NVM Express® Technical Errata

Errata ID	109
Revision Date	08/05/2022
	NVM Express [®] Base Specification Revision 2.0b
	NVM Express [®] NVM Command Set Specification Revision 1.0b
Affected Spec Ver.	NVM Express [®] Zoned Namespace Command Set Specification Revision 1.1b
	NVM Express [®] Key Value Command Set Specification Revision 1.0b
	NVM Express® Management Interface Specification 1.2b
Corrected Spec Ver.

Errata Overview

This ECN updates and clarifies various text within the NVM Express Base Specification Revision 2.0b, NVM Express NVM Command Set Specification Revision 1.0b, and NVM Express Key Value Command Set Specification Revision 1.0a.

Figure 47: NVMe-MI Send Command Response Message to NVMe Admin Command CQE Mapping Diagram

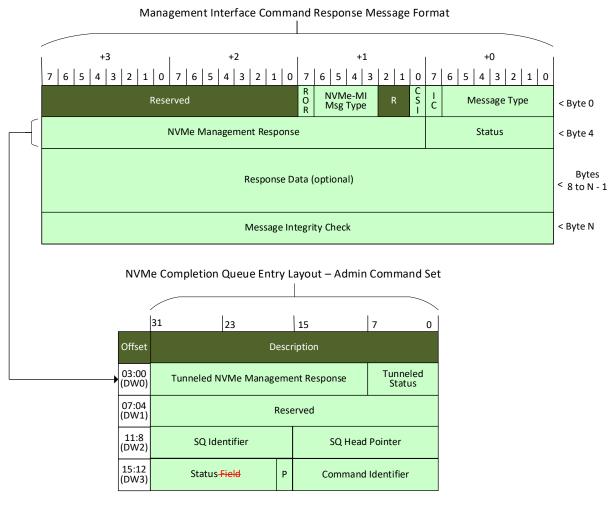
4.3.1.1 NVMe-MI Send Command Request Message to NVMe Admin Command SQE Mapping
